From:	Goodwin, Eoanna (REC)
Sent:	Thursday, August 14, 2025 10:13 AM
To:	Aaron Fenton; Zorana Bosnic
Cc:	Brian Jencek; Roana Tirado; Vera Yang; Queenie Lyu
Subject:	RE: Embarcadero Plaza - Block/Lot Map

From: Goodwin, Eoanna (REC) <eoanna.Goodwin@sfgov.org>
Sent: Wednesday, August 13, 2025 10:06 AM
To: Brian Jencek <brian.jencek@hok.com>
Cc: Aaron Fenton <afenton@bxp.com>
Subject: Embarcadero Plaza - Block/Lot Map

Thanks for all the hard work! We reviewed and made some comments to the deck. Right now, the deck does not respond to two of our most vocal groups and it should. While we may have done our homework on the trade offs, it is vital to show it. In addition, while the skateboard elements will be integrated, it too isn't well represented. These could be talking points, but as we know, most folks who took the survey didn't attend the meeting.

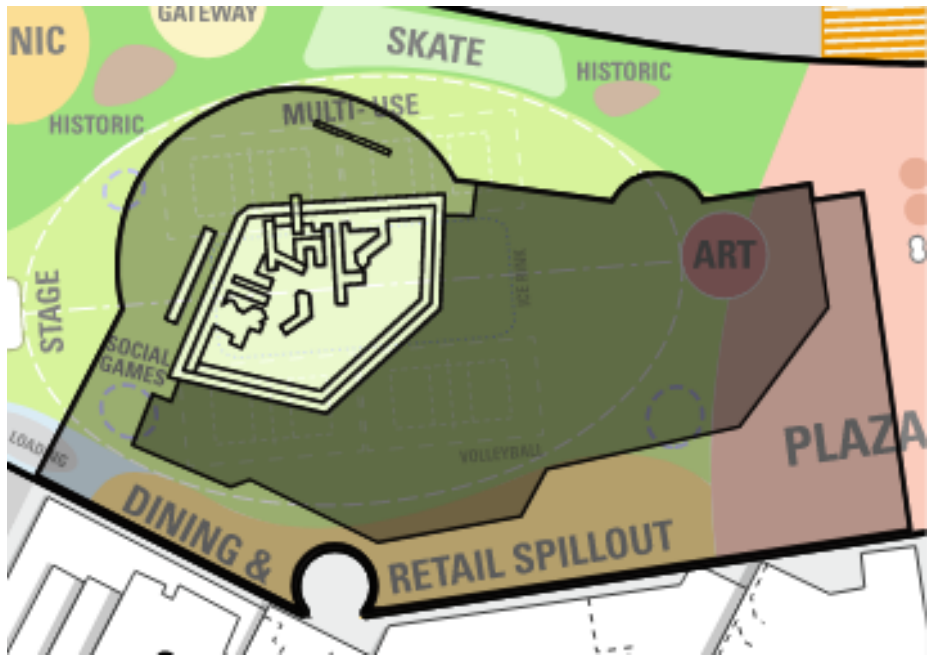
- (added fountain - slide 25): In addition to showing the fountain on sl. 22, add one more slide 24 “Park Program Diagram” with the fountain outline within the “multi-use” area, with the pump room and level change, like below, but no shade. List the “tradeoffs” on the right side (no stage/ events; no play fields; limited games/ fitness etc.)

- “Truly Multi Use Park” - replace one of the images (say volleyball, bottom left image) with the skateboard image you added on the top right.
- (Slide 28) Add skateboard image(s) as part of the “Plaza”- Station 3: Can you send us what image you want to include so we are not guessing?
